Title									
Wire Harness, On/Off Switches to LHE								Mellinger	
Size B	Document Number <Doc>								Rev C
Date:	Thursday, September 03, 2020					Sheet	1	of	1

WH-On/Off Switches (Bulkhead)

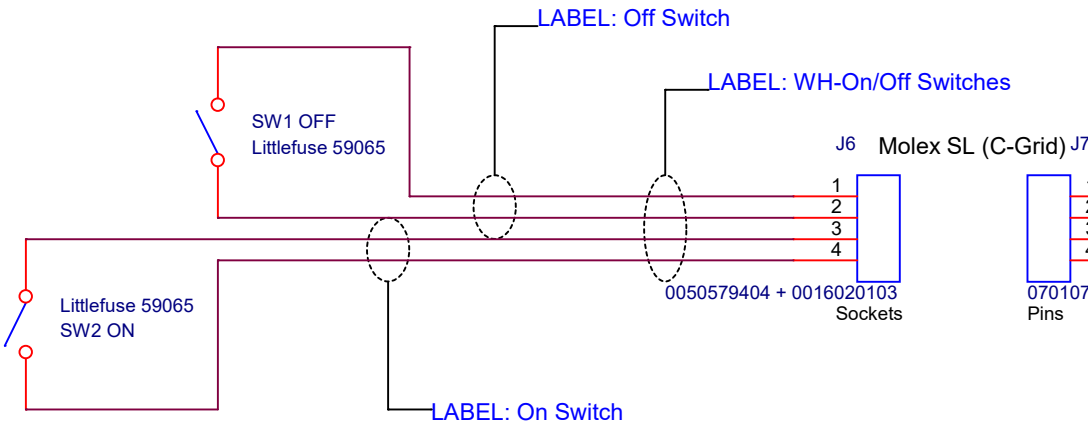
As built notes:
CPF #3 don't know length; colors as below except wire connecting pin 3 to pin 1 on C-grid is orange.

CPF #2 wires are all black; harness to LHE is 58in;
SW1 wires are 7in, and SW2 wires are 12in.
